STAFF RECOMMENDATION

**118 South 11th Street
March 17, 2021**

Application: New Construction—Infill
District: Lockeland Springs-East End Neighborhood Conservation Zoning Overlay
Council District: 06
Base Zoning: MUL-A
Map and Parcel Number: 08309022600 and 08309022500
Applicant: Gina Emmanuel, Centric Architecture
Project Lead: Melissa Baldock melissa.baldock@nashville.gov

Description of Project: Applicant proposes to construct infill on a vacant lot due to the March 3, 2020 tornado.

118 SOUTH 11TH STREET

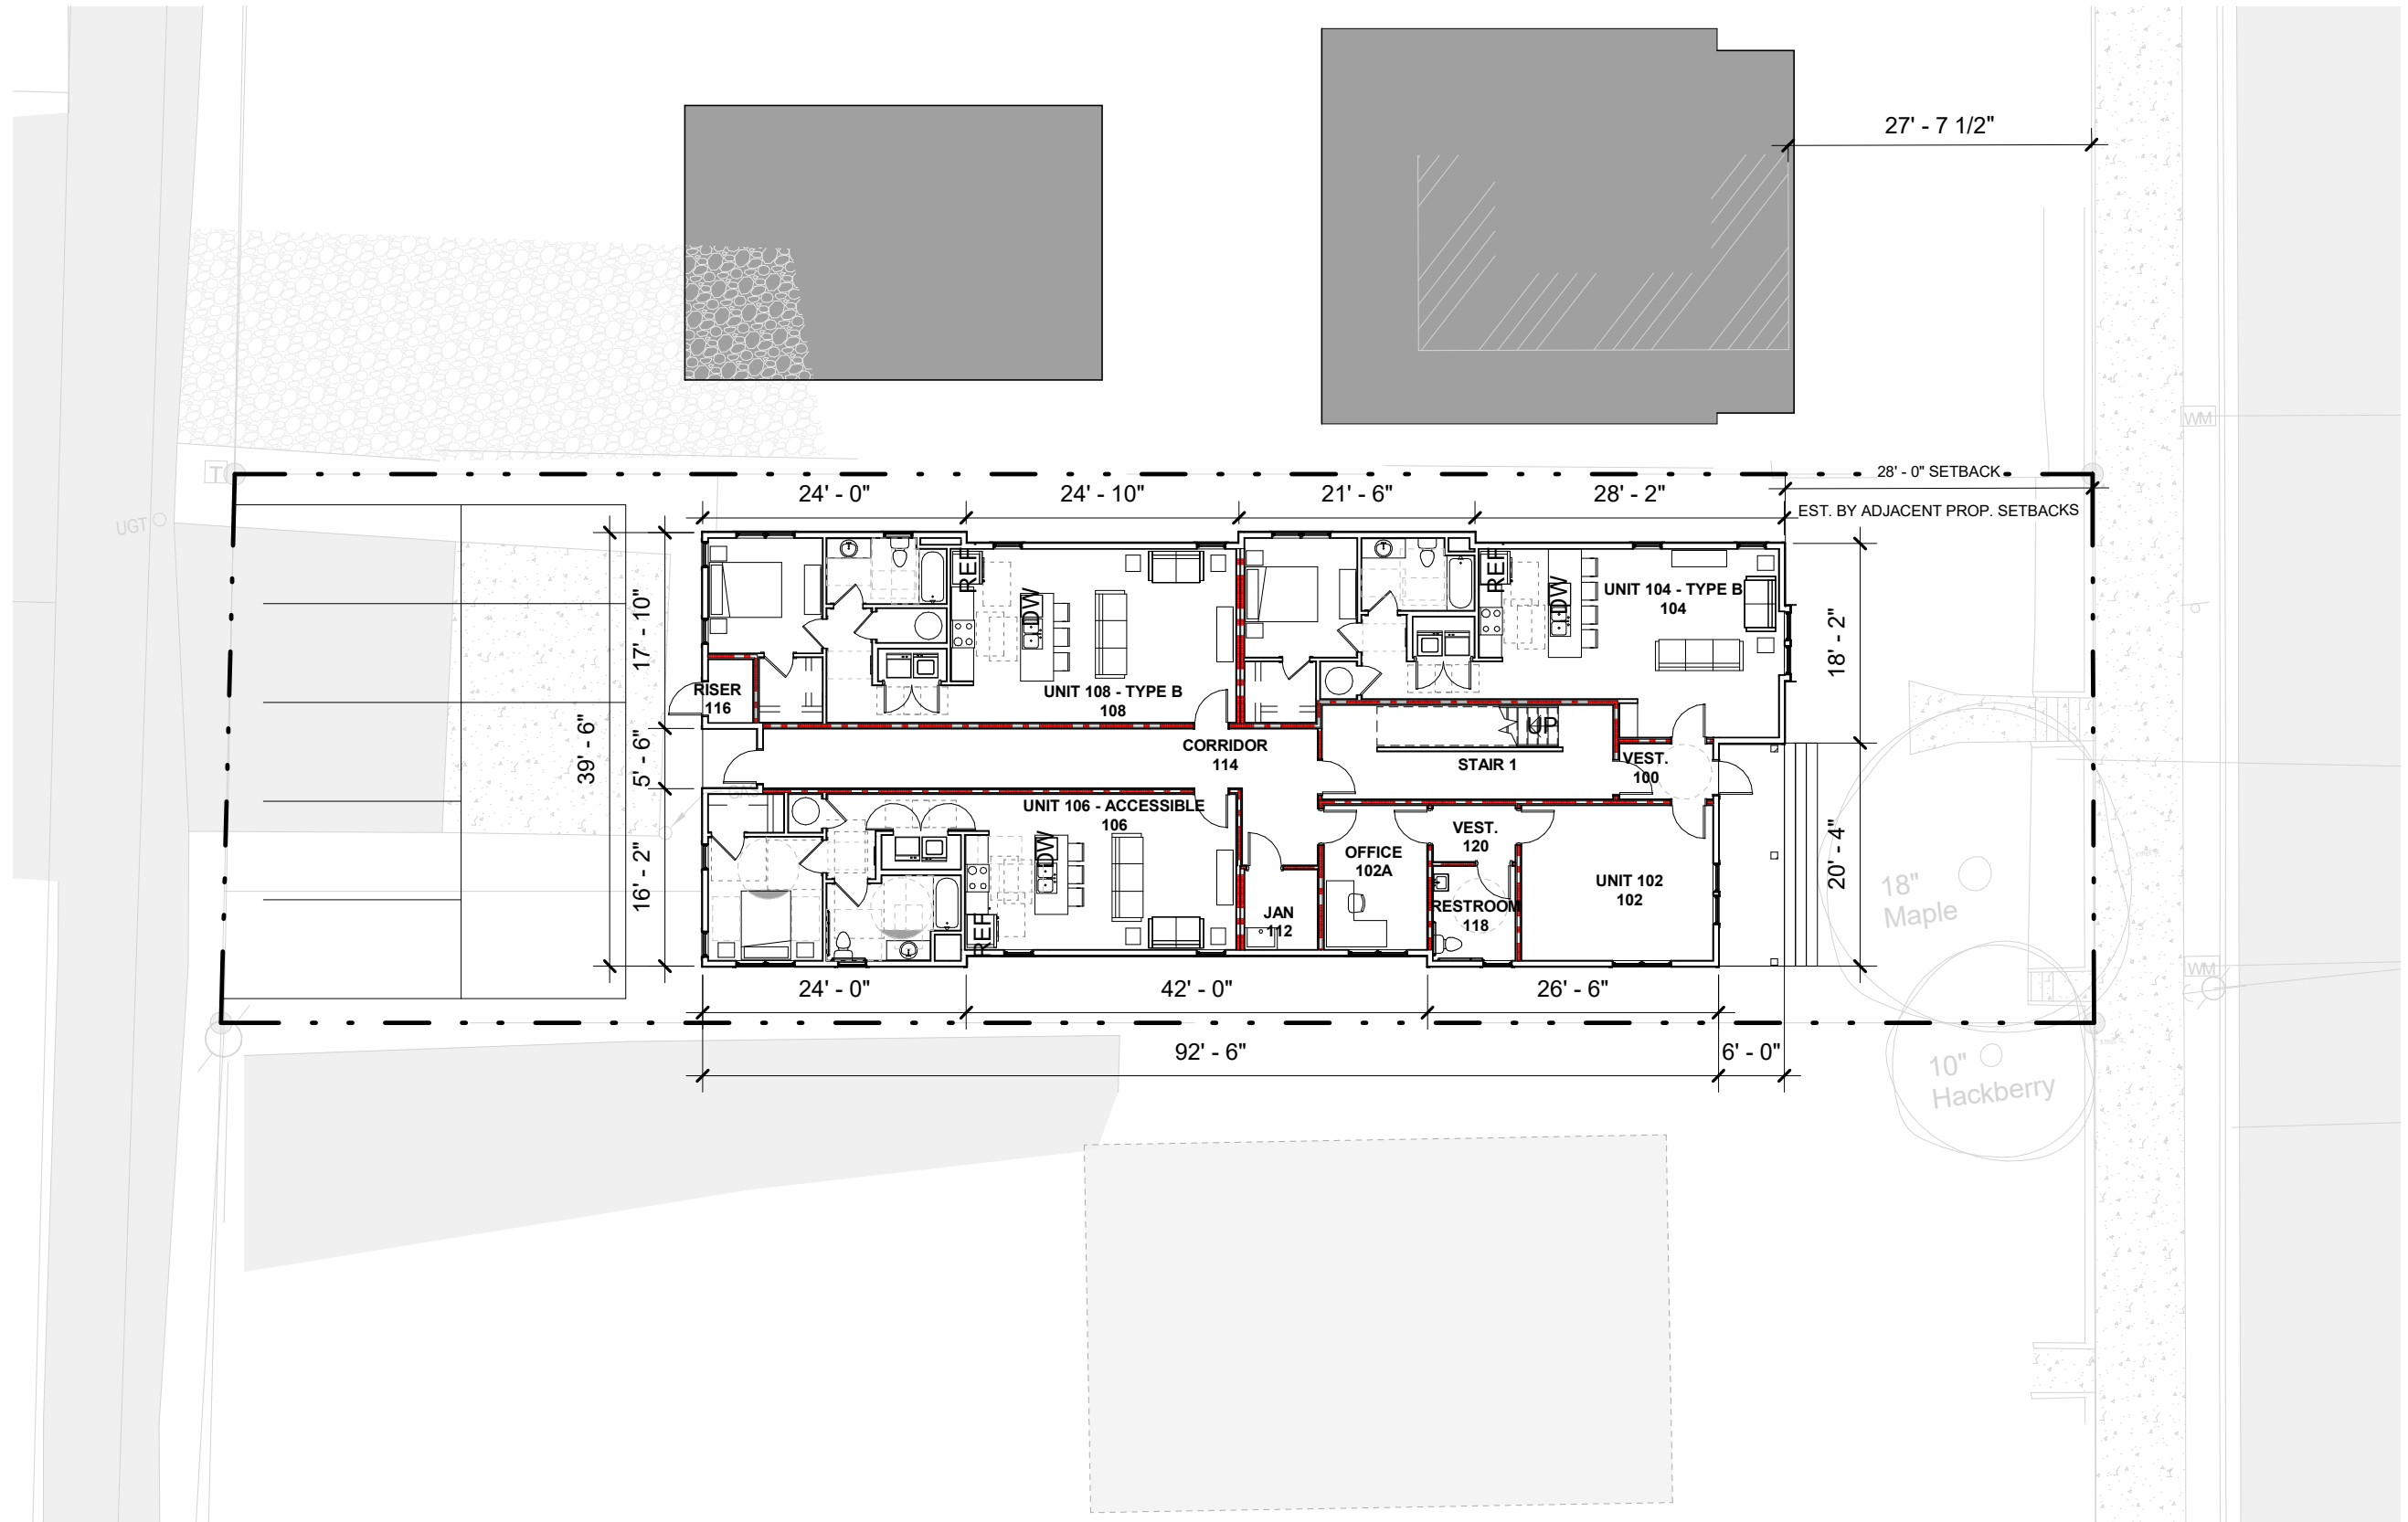
Setback & Rhythm of Spacing: The infill meets all base zoning setbacks. It will be centered on the lot and will be five feet, one inch (5'1") from the left property line; five feet, two inches (5'2") from the right side property line, and over forty feet (40') from the rear property line. The front setback will be approximately twenty-eight feet (28'), which is similar to the house next door at 116 South 11th Street. (The house on the other side at 120 South 11th was also demolished after the tornado and MHZC has yet to review or approve infill on that lot).

Orientation: The house is oriented to face South 11th Street, meeting the historic context. It has a partial width front porch with a depth of six feet (6'). Staff recommends a walkway from the sidewalk to the front porch. Vehicular access to the site will be via the rear alley, and uncovered parking will be at the rear of the lot.

1. The finished floor height be consistent with the finished floor heights of the adjacent historic houses, to be verified by MHZC staff in the field;
2. A front walkway from the sidewalk to the front porch be added;
3. The rear twenty feet (20') have a one or one-and-a-half story form and a lower height;
4. The front porch columns have a cap and a base;
5. Staff approve the roof shingle color, the metal roof color and dimensions, a masonry sample, and all windows and doors prior to purchase and installation; and
6. The HVAC be located behind the house or on either side, beyond the mid-point of the house, and utility meters shall be located on the side of the building, within 5' of the front corner. Alternative mechanical and utility locations must be approved prior to an administrative sign-off on building permit(s).

ELEVATIONS

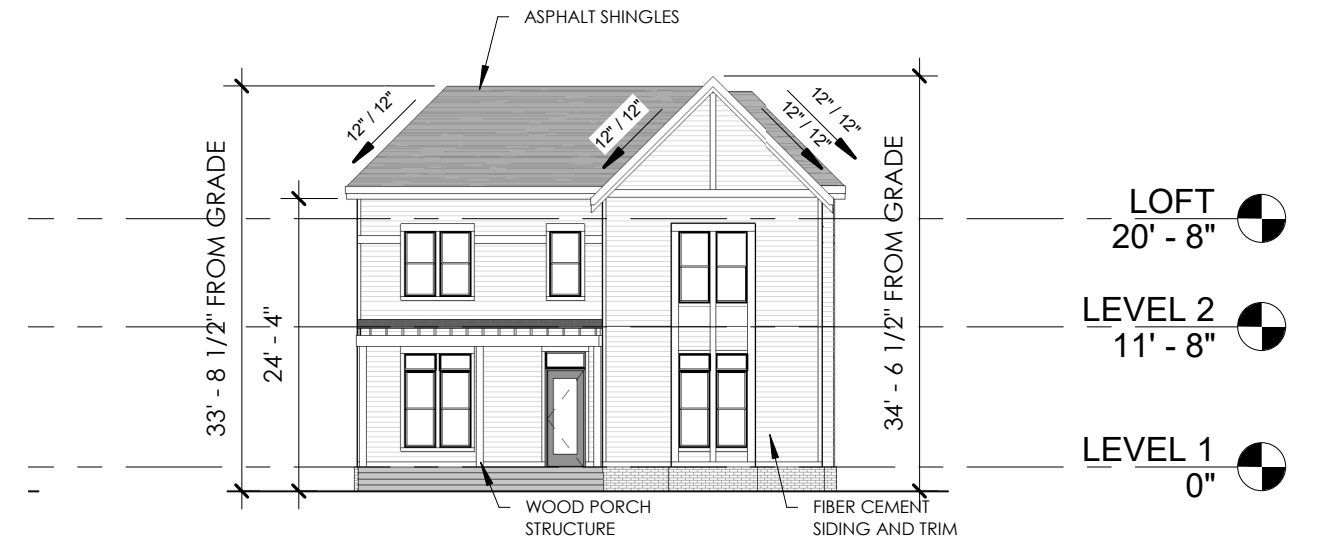
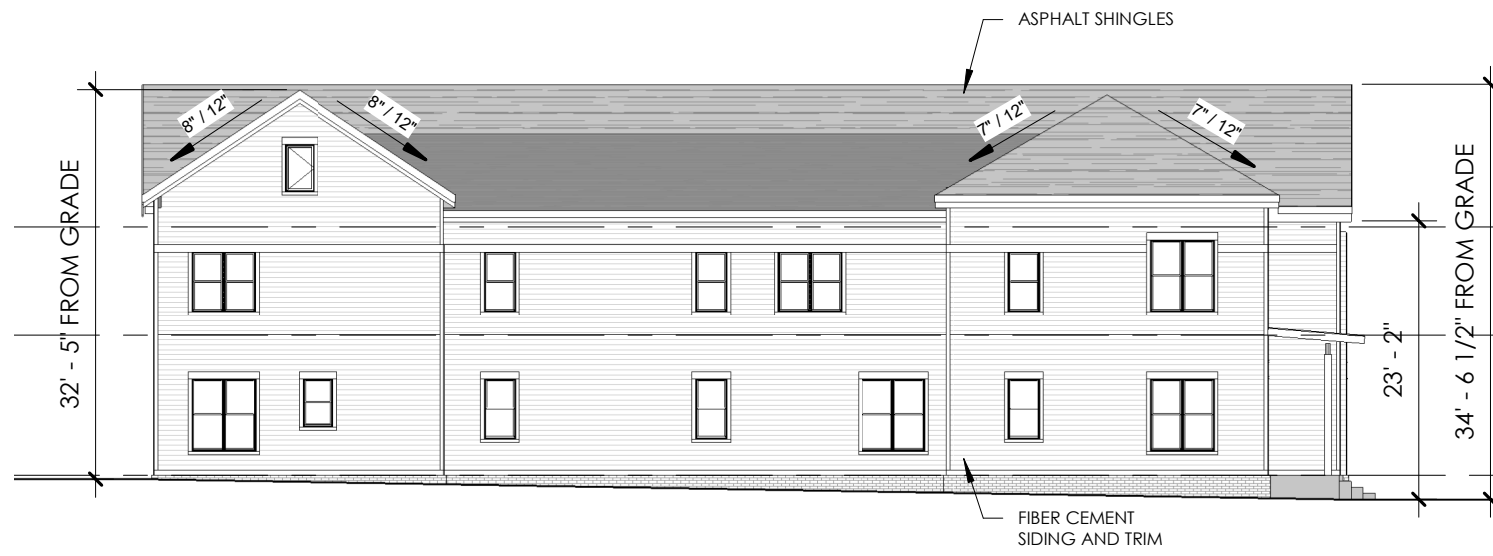
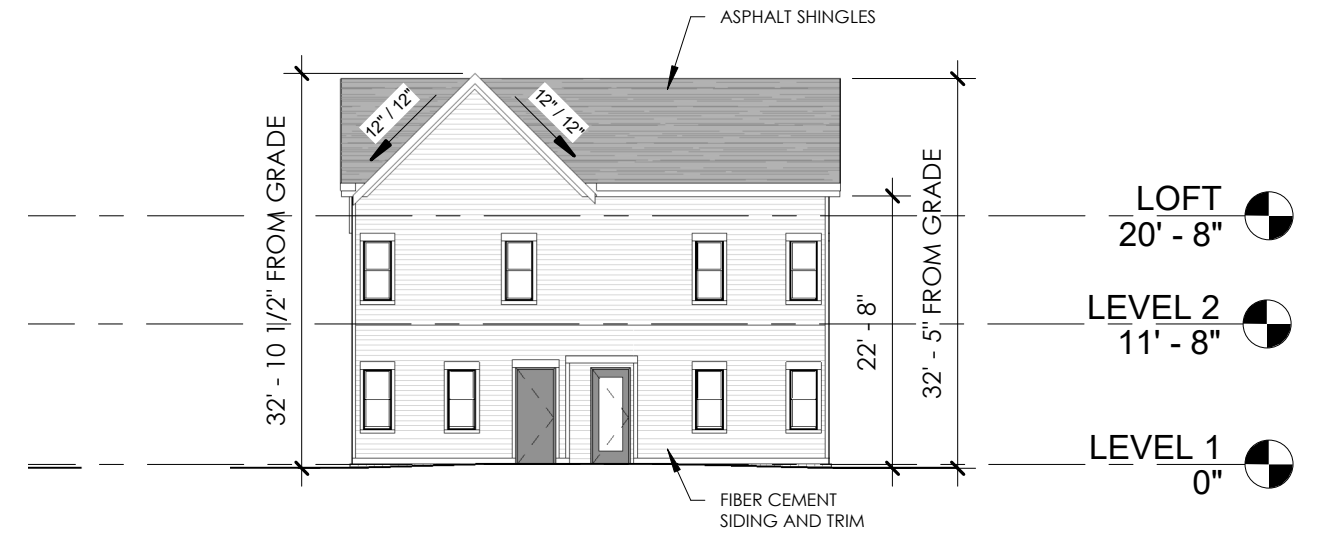
Height & Scale: The proposed infill is a full two stories in height. Staff finds that this meets the historic context, as there are several two story houses in the immediate vicinity, including the house next door at 116 South 11th Street and 123, 125, and 127 South 11th Street, directly across the street. The addition's height of thirty-four feet, six inches (34'6") from grade and width of thirty-eight feet, two inches (38'2") at the front and thirty-nine six inches (39'6") towards the back are similar to other two story houses in the immediate vicinity.

Although the height and scale are similar to houses in the immediate context, staff finds that the infill's depth and overall scale are not. The infill has a depth of ninety-eight feet, six inches (98'6"), which is significantly deeper than the other two story houses in the immediate vicinities, which have depths ranging from forty feet to sixty-two feet (40'-62'). The depth does not meet section II.B.2. for its mass in relationship to open spaces. The fact that the entire depth is a full two stories makes the overall scale incompatible with the immediate historic context. Staff recommends that a condition of approval be that the rear twenty feet (20') have a one or one-and-a-half story form and a lower height.

Roof form: The infill's primary roof form is a gabled-ell, with a front facing gable and a hip. Such a roof form is found in the immediate historic context on 1103 Holly Street and 205 South 12th Street, and staff finds it to be appropriate. The front facing gable will have a 12/12 pitch and the hip will have a 7/12 and a 12/12 pitch. The side facades incorporate 8/12 gables to break up their long depths. Staff finds that these gable forms do not go far enough to reduce the overall scale of the infill. Staff therefore recommends that the back twenty feet (20') of the infill have a one or one-and-a-half story roof form.

With the condition that the rear twenty feet (20') be one or one-and-a-half stories in scale and lower in height, staff finds that the infill's height and scale to meet Sections II.B.1.and II.B.2. of the design guidelines.

With the condition that the back twenty feet (20') of the infill have a one or one-and-a-half story roof form, staff finds that the infill's roof form to meet Section II.B.5. of the design guidelines.
